## Committee of the Whole Report

### For the Meeting of November 18, 2021

**Subject:** Rezoning Application No.00710 for 1905 Lee Avenue

A5

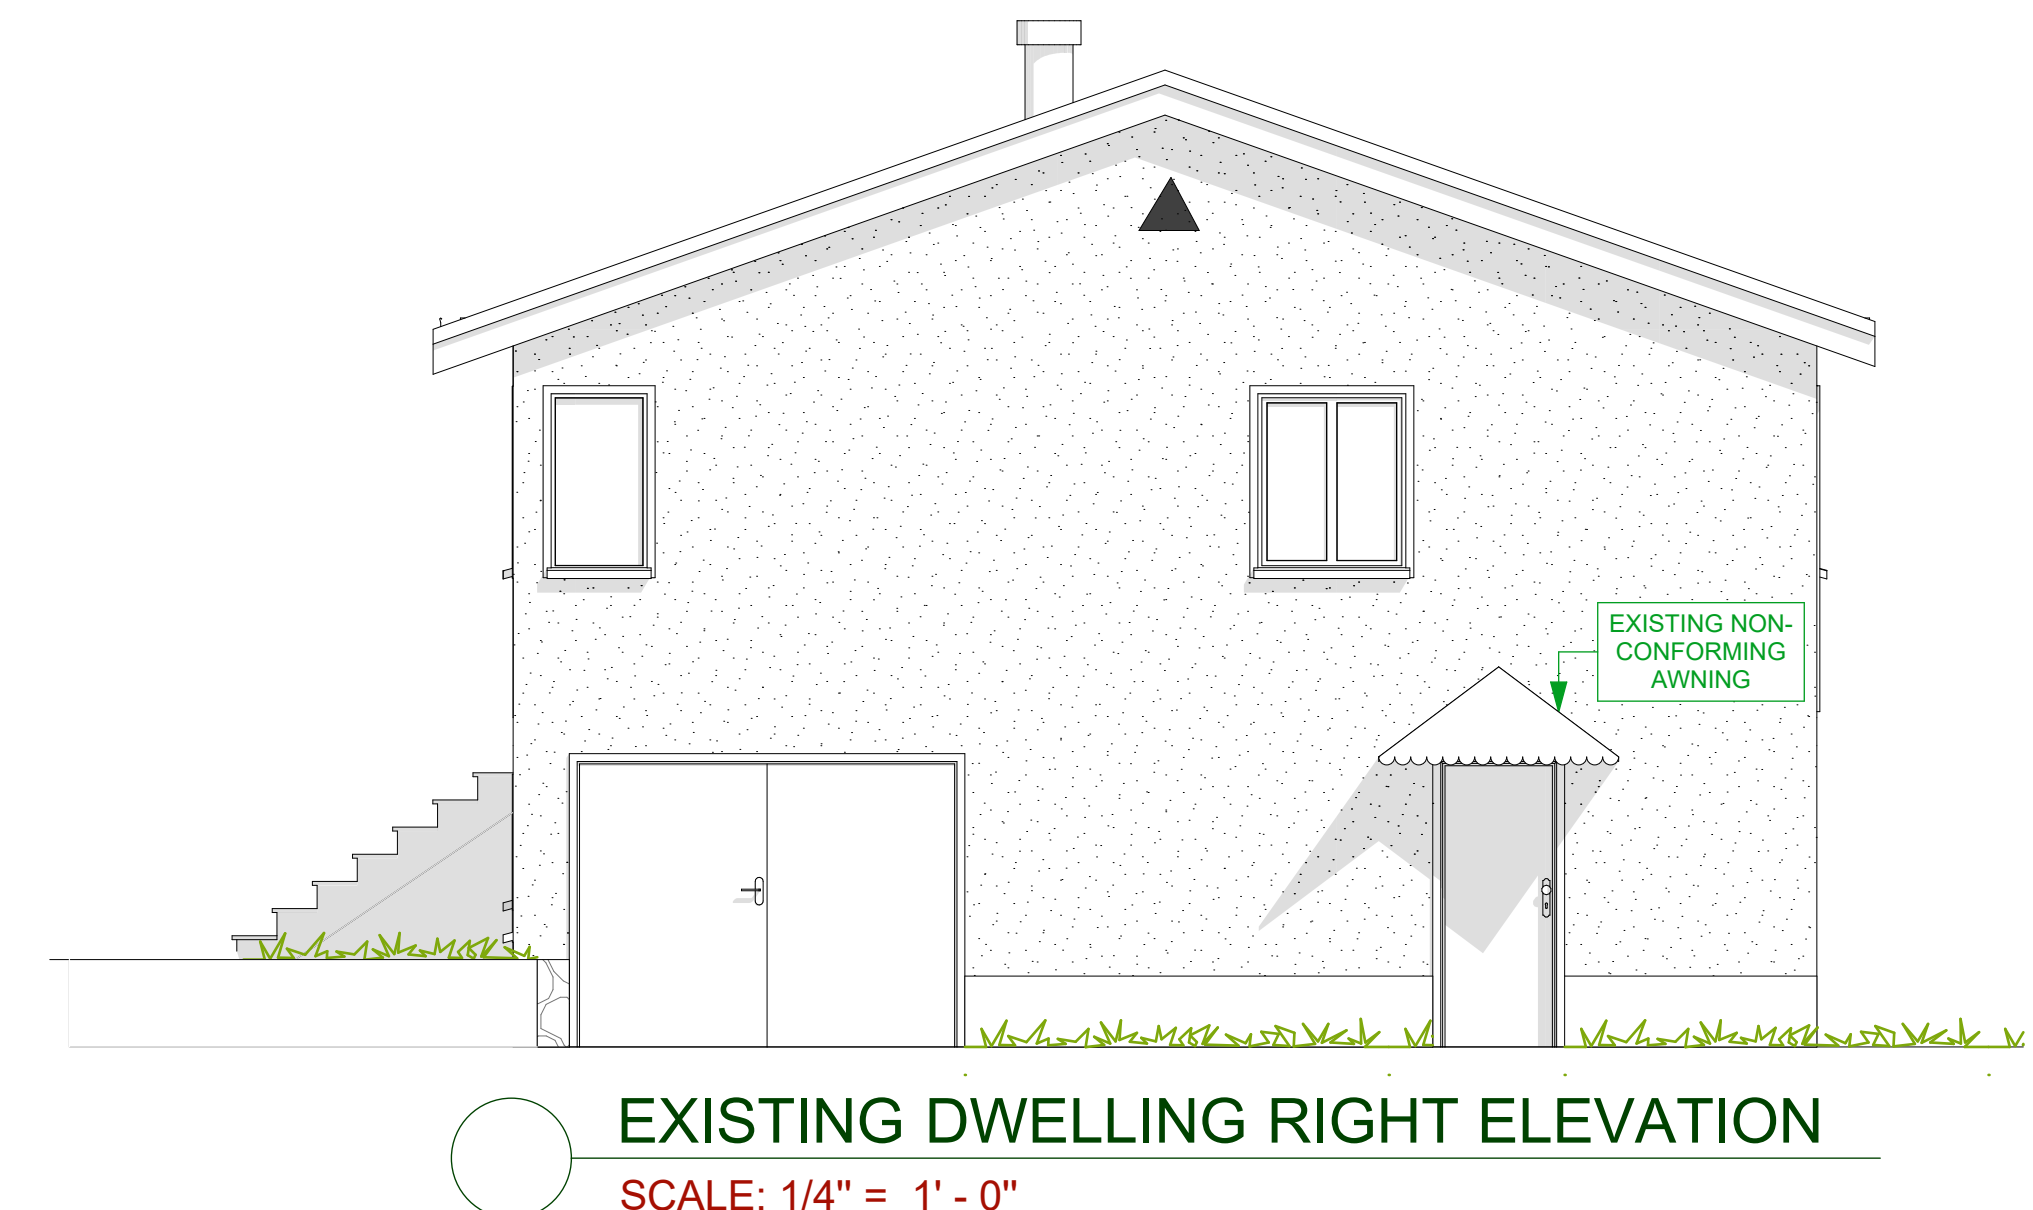
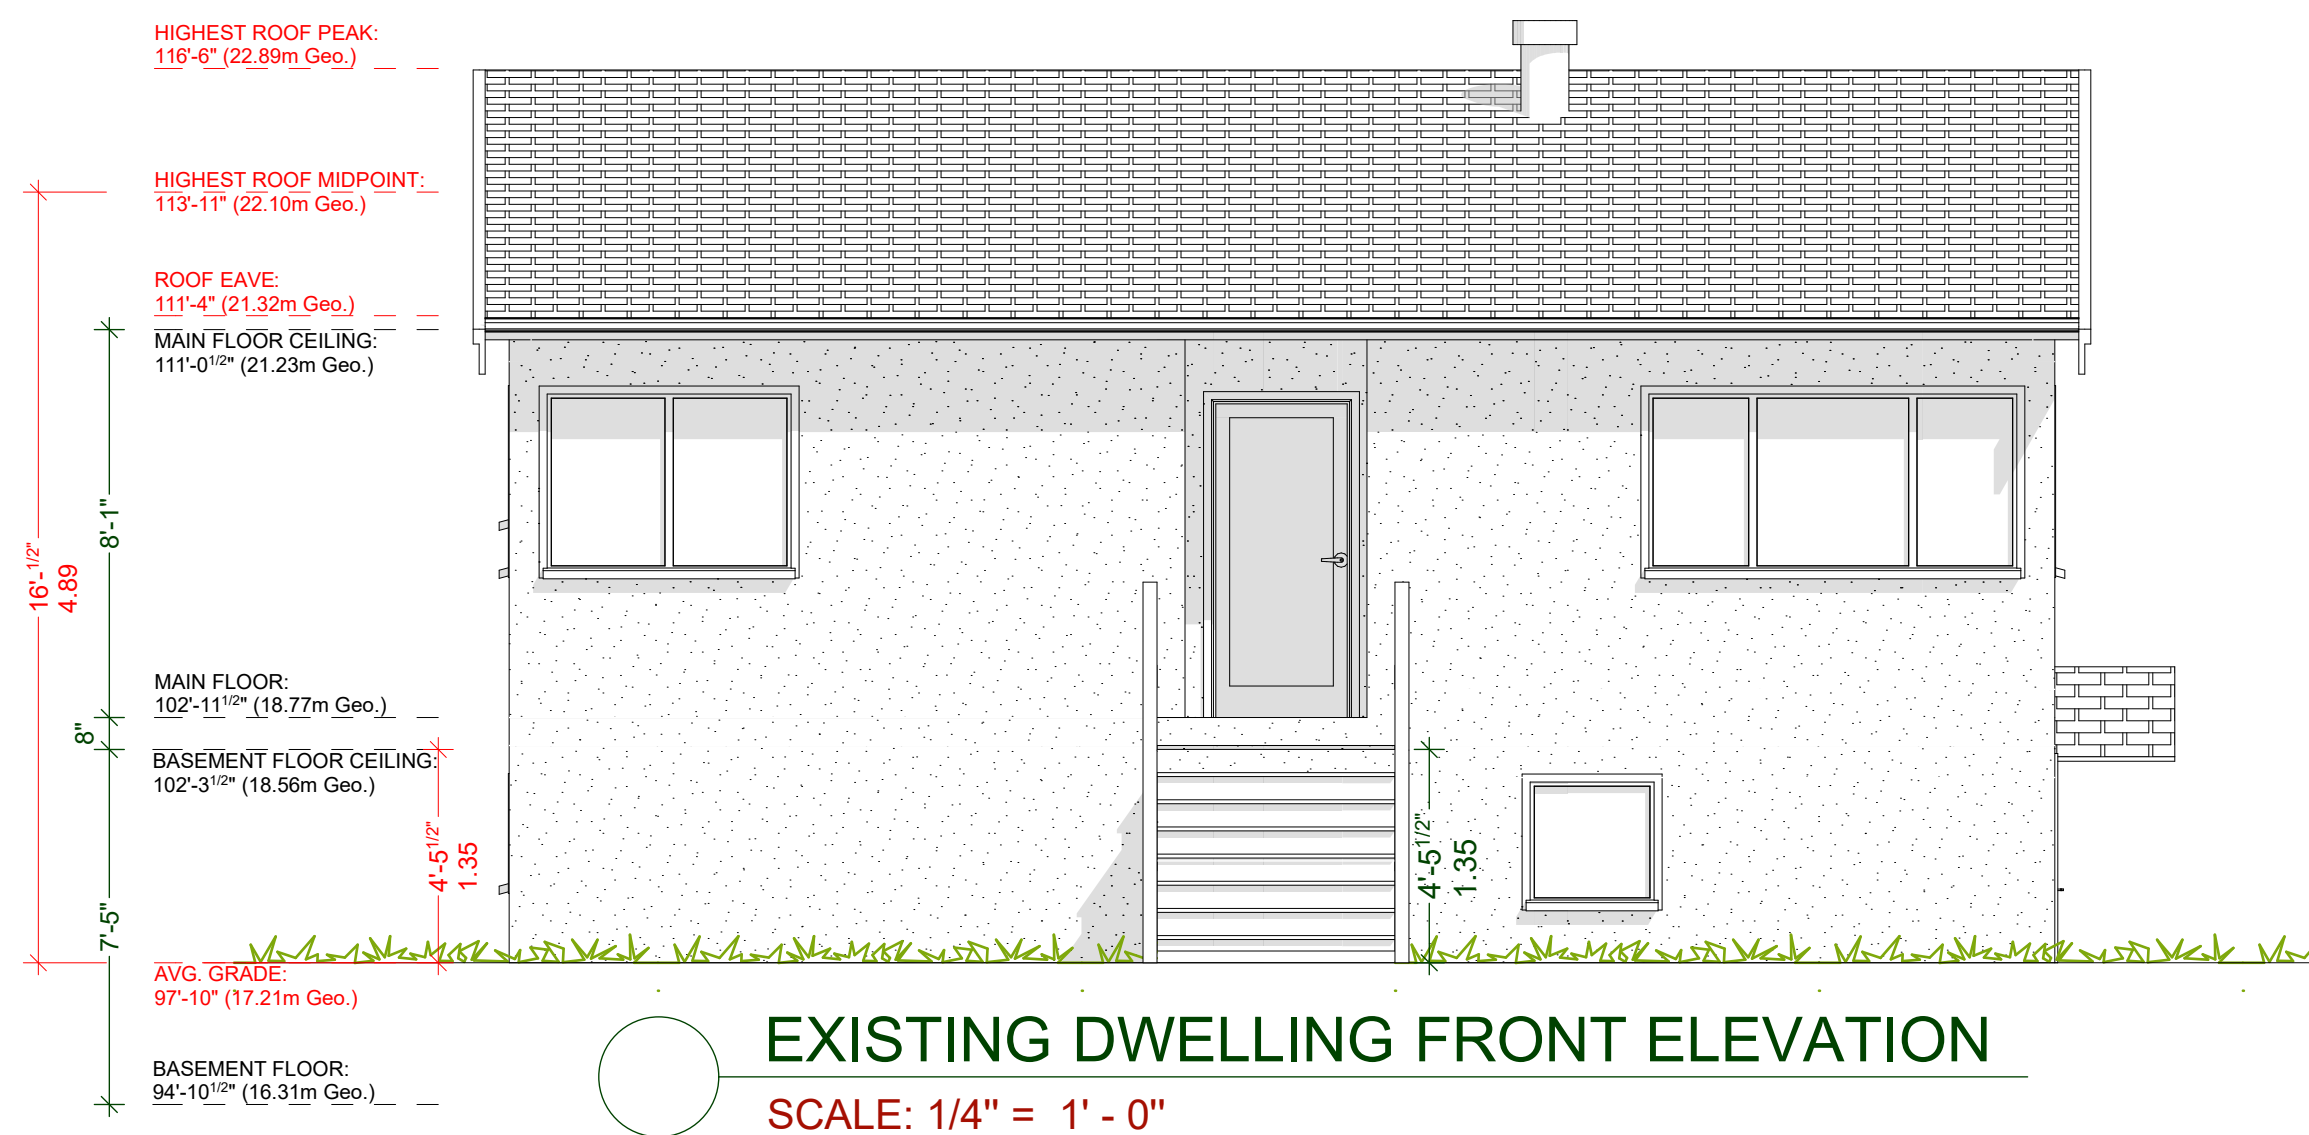
- The variances associated with the existing house are to reduce the rear and north side yard setback. The side yard setback is not actually changing but a variance is triggered because the regulations in the R1-S2 Zone require greater setbacks to habitable windows than the current zoning. Since there is no actual change proposed, it is considered supportable. The reduced rear yard setback results in a rear yard which would be just over two metres deep and does not create a usable outdoor space for residents.

- i. Provide a usable outdoor space for the existing house
3. Once design revisions are made, discuss plans and re-petition immediate neighbours as per the Small Lot Policy.

**Figure 5.** Detail of the floating drive required to retain tree # 7.

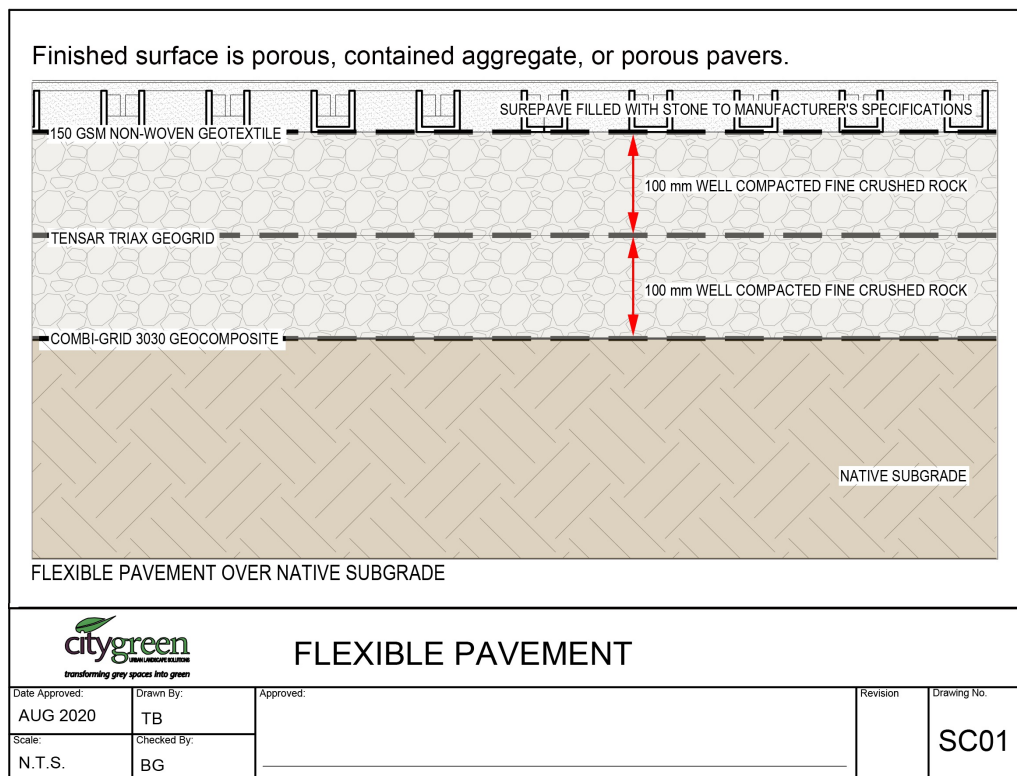
The new driveway is right over the roots of tree # 7. In order to retain this tree the new driveway needs to be porous and be floated over the ground so that there is no root damage. I have shown the required specification in Figure 5.

If that cannot be accomplished then tree # 7 will need to be removed. A standard driveway installation requires excavation of surface grades, and installing and packing a new subgrade, and then creating the finished surface, all of which removes and kills the roots, killing the tree.

However, I see no need to remove tree # 7 if the floating pavement design shown in Figure 5 is used.
